SUBJECT: COMANCHE PEAK STEAM ELECTRIC STATION  
CPSES TO INFORMAL NRC QUESTION ON ECCS  
SWITCHOVER

NRC REACTOR SYSTEMS BRANCH QUESTION  
ON REACTOR OPERATOR FAILURE TO COMPLETE  
ECCS SWITCHOVER FOLLOWING A LOCA

FIGURE 1  
CPSES ECCS SWITCHOVER SCHEMATIC

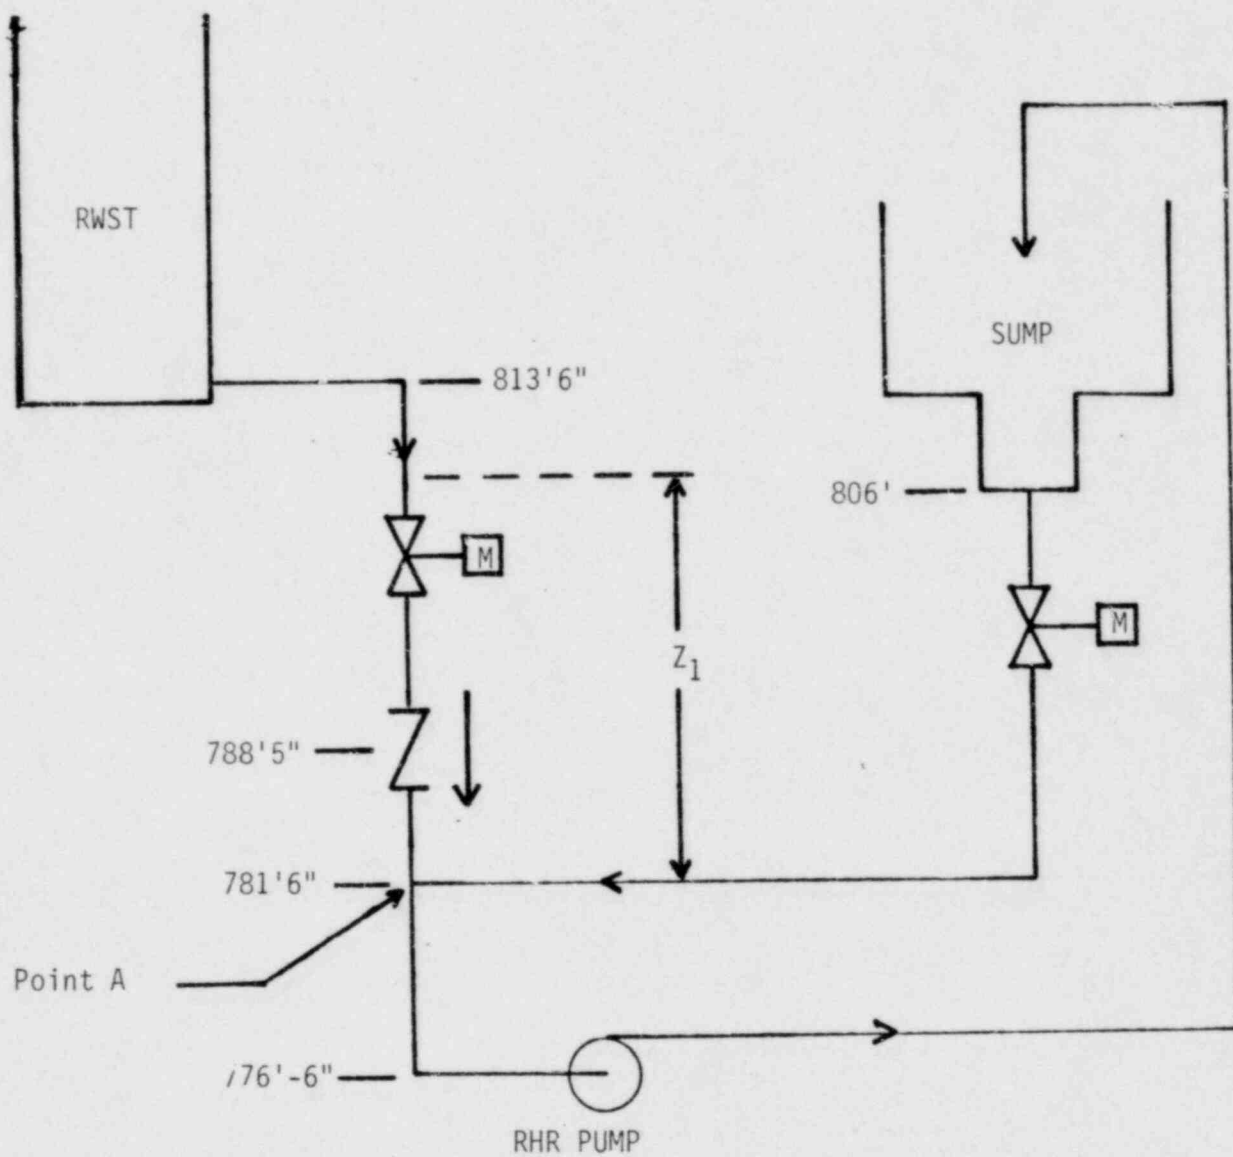
Question: Will the Reactor Operators' failure to complete manual operations (following LOCA) to switchover the ECCS from the injection to the recirculation mode jeopardize the recirculation mode?

Answer: We have completed a calculation which shows that a Reactor Operators' failure to manually switchover the ECCS does not jeopardize the recirculation mode. During the injection phase of ECCS the RHR pumps are taking suction from the RWST. At the low-low level (829'2") in the RWST the sump valve in the line from the sump to the RHR pump suction, open automatically so that the RHR pump is taking suction from both the RWST and the sump. The operator close a valve in the line from the RWST to the RHR pump suction. Our calculation shows that failure to close this valve has no effect on the RHR pump operation, hence the recirculation mode of ECCS, because an adequate water leg exists in the piping line from the RWST to the RHR pump suction. The calculation is presented here.

Calculation: A schematic diagram of one RHR train is provided in Figure 1.

1. The motor operated valve in the piping line from the RWST to the RHR pump suction is open.
2. Piping losses are based on RHR system runout flowrate (4500 gpm).
3. The water level in the sump is at the bottom elevation of the sump.
4. Containment pressure is atmospheric (0.0 psig).
5. Sump water temperature is 212°F; RWST water temperature is 32°F.

The pressure at point A (see Figure 1) is given by (1) and (2).

$$Z_1 = \frac{\rho_{\text{sump}}}{\rho_{\text{RWST}}} \left[ (Z_{\text{sump}} - Z_A) - h_{\text{pipe}} \right] \quad (5)$$

$$Z_1 = 19.9 \text{ ft}$$
